PLANNING AND ZONING BOARD STAFF REPORT

American Social - Waivers

Meeting	File No.	Application Type
May 19, 2025	2025-090-ARC-WAI-LV1	Level 1 Site Plan Revision with CBD Waivers
Property Owner	Applicant/Authorized Agent	
Delray Trio, LLC	Miskel Backman LLP

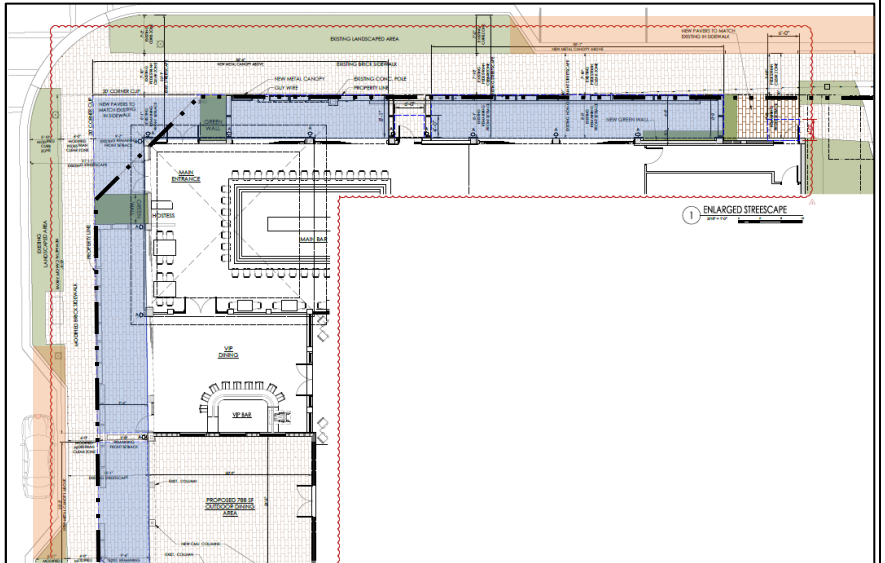
The request is to exceed the maximum allowable awning setback encroachment of four feet to allow an encroachment of 9 feet and 7 inches, shown in blue at right. The awnings are proposed to cantilever to the property line. The existing building has a variable nonconforming setback, and the awning will encroach **9 feet 7 inches** at the furthest point. The awning will also encroach into the ROW at the corner which will require acceptance of a hold harmless agreement, although this is not part of this subject request. Similarly, the awning will be required to meet minimum vertical clearance requirements over the sidewalk.

The request is to omit the required four-foot curb zone, providing a curb zone width of 0 feet for a portion of the streetscape where existing on-street parking spaces are located (shown in orange, above). While the minimum fifteen feet of total streetscape is still provided, the Applicant is proposing that the balance of the streetscape gained from the omission of the curb zone be redistributed to the pedestrian clear zone and remaining front setback area, with an intended use as an expanded outdoor dining area (subject to separate review and approval under the sidewalk café program).

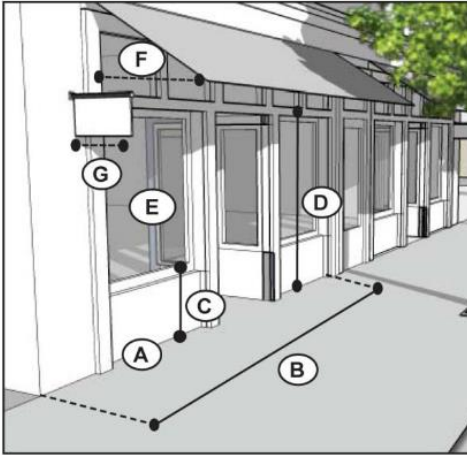
The applicant is requesting to exceed the maximum awning setback encroachment of four feet along the north and west façade adjacent NE 1st Street and NE 2nd Avenue. The required setback for the property is a minimum of 10 feet and maximum of 15 feet. The existing structure is nonconforming with a setback that ranges from 8 feet to 8 feet and 1 inch for the north façade, and 9 feet and 6 inches to 9 feet and 7 inches for the west façade.

The proposed awning would cantilever over the outdoor dining seating and would extend to the property line, encroaching approximately 8 feet in depth for the north façade and 9 and a half feet in depth for the west façade. (Note: The outdoor dining requires review and approval through the sidewalk café permit process).

Due to the required 20’ by 20’ corner clip dedication at the intersection of NE 1st Street and NE 2nd Avenue, the existing structure will encroach slightly into the public ROW at the corner. A hold harmless is required for the existing structure and the proposed awning overhang within the public ROW.

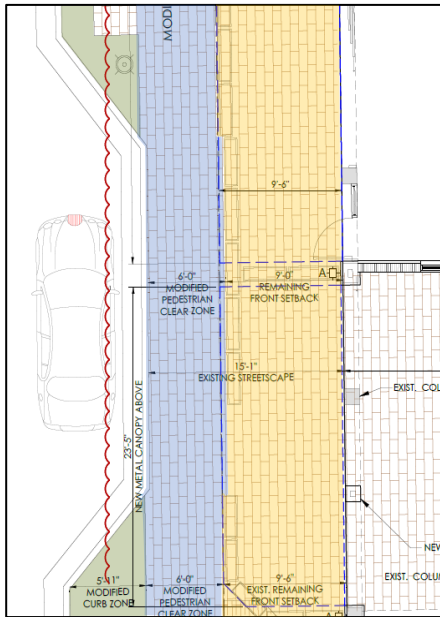
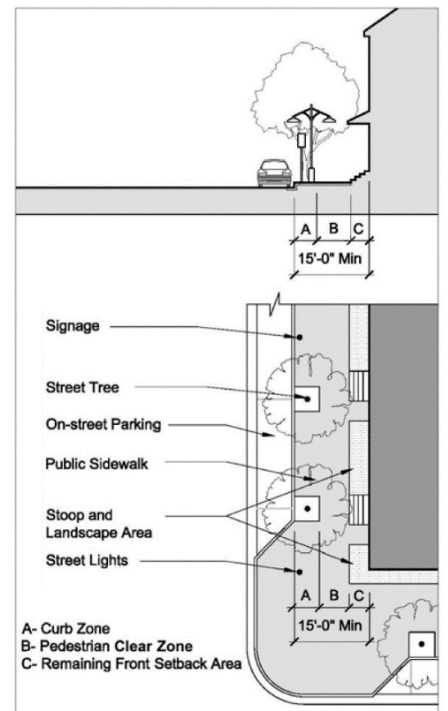
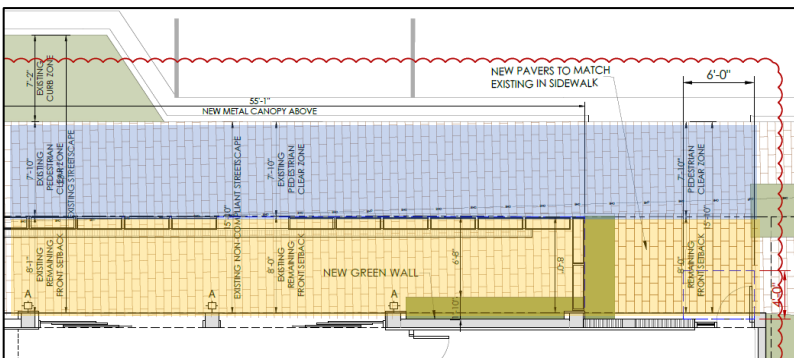
Pursuant **LDR Section 4.4.13(E)(2), Streetscapes**, front setback areas, which include side setback areas facing streets, shall be detailed to augment public right-of-way design, to establish shaded, continuous routes for pedestrians, and to organize landscaping and other elements to ensure a superior public realm. The proposed restaurant abuts a ROW on the north and west; therefore, a streetscape design that provides a superior pedestrian experience and incorporates the elements detailed in **LDR Section 4.4.13(E)(2)** is required for each side. The required streetscape width includes a curb zone (4 feet), a pedestrian clear zone (6 feet) and the remaining front setback area (5 feet), equating to a total minimum 15-foot streetscape design.

The proposed streetscape meets the minimum dimensional requirements for most of the subject site, providing continuous sidewalk, street trees and lighting. However, the applicant is requesting to reduce the curb zone width from the required remaining 4 feet to 0 feet adjacent to on-street parking spaces. The curb zone is measured from the back of curb to the pedestrian clear zone and typically accommodates street trees and public infrastructure needs such as utility poles, streetlights, street signs, parking meters, etc. The pedestrian clear zone, depicted in blue, and the remaining front setback, depicted in yellow, complies with the required dimensions along the areas seeking curb zone relief; west façade proposes a 6-foot pedestrian clear zone and 9-foot remaining front setback, and north façade proposes a 7-foot 10-inches pedestrian clear zone and 8-foot remaining front setback. The overall streetscape dimensions comply with the required 15 feet throughout the site. Likewise, the Applicant has proposed the addition of three shade trees where none currently exist along NE 1st Street within the portion of the streetscape where the curb zone is provided. This is a clear improvement in quality over the existing

In consideration of the criteria findings listed previously, it is important to clarify that the Applicant is essentially proposing to reallocate the four feet that would be required for the curb zone and is instead distributing the four feet to accommodate an expanded dining area, subject to a future sidewalk café permit, and an expanded pedestrian clear zone along the North sidewalk. The Board should consider if this is an acceptable trade-off that improves the quality of the pedestrian experience (that should be available to all individuals downtown), or whether the omission of the curb zone for a portion of the streetscape diminishes public
